5270000 DETECTABLE WARNINGS
INTERNAL/INDUSTRY REVIEW COMMENTS

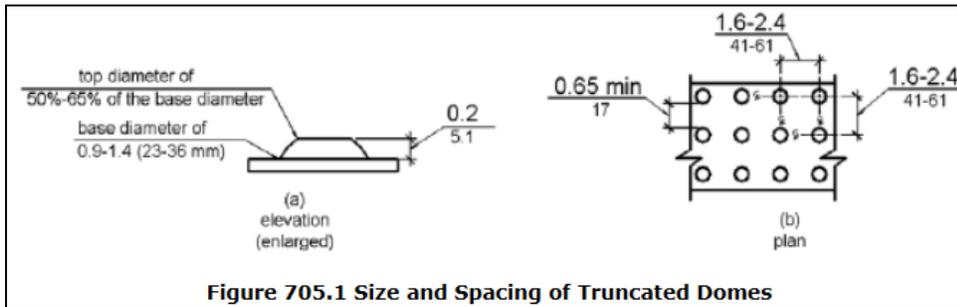
4. Section 527-4: Number 2. of the list says that 90% of the individual domes must be in accordance with 705 of ADA Standards (see screenshot below). I know this language was removed from the General Notes of Index 304, however this would be very difficult for inspectors to quantify. Are they supposed to measure and count each individual dome? Should we instead only allow preformed mats that meet 705 and be listed on the APL?
